PROJECT NAME
3014 WEST
SUBDI

PETITION NO: Z-14

ZONING COMMENTS:

Z-14 RICHARD DUNCAN

ZONING PLAN
DRAWING TITLE

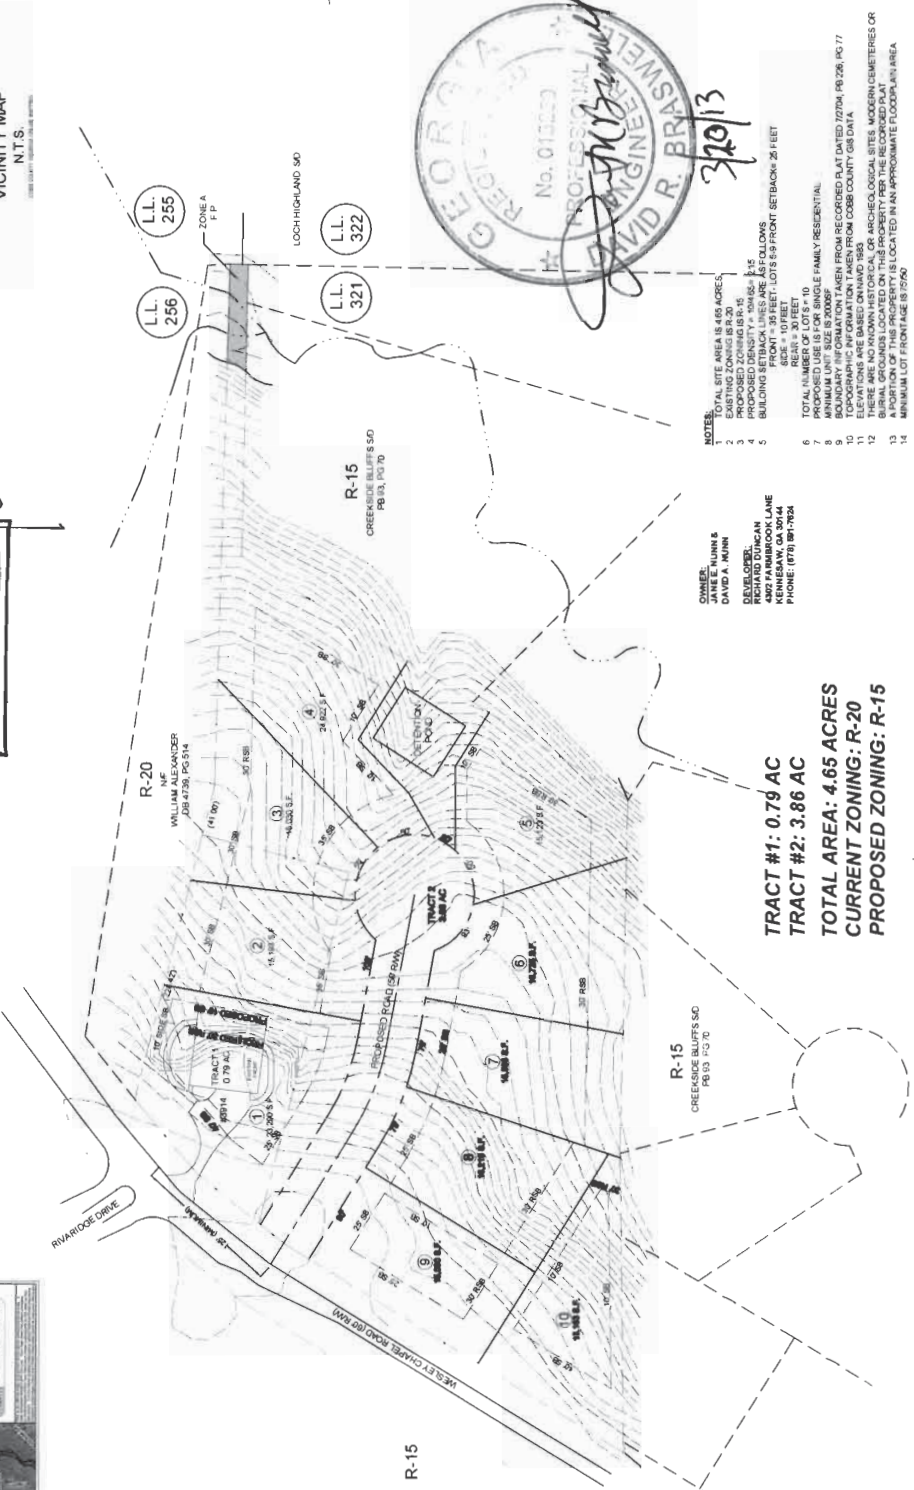
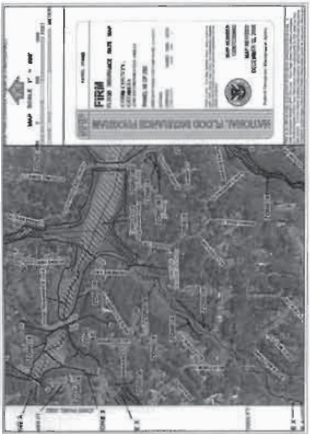
2. Due to the sensitive nature of the area, increased rear and decreased front setback are encouraged to limit site disturbance and impervious driveway coverage. Land disturbance on the steeper slopes at the rear of lot 5 should be limited by utilizing a drop foundation.

3. Drainage easements and adequate drainage swales must be provided at the rear of lots 4 and 5 to limit offsite runoff bypass.

Recommend curb and gutter along both sides and sidewalk along one side of proposed development roadway. The proposed sidewalk from the development should connect to the proposed sidewalk on Wesley Chapel Road.

Recommend development roadway either directly align or have an offset of a minimum of 125 feet from Rivaridge Drive per Development Standard 401.10.
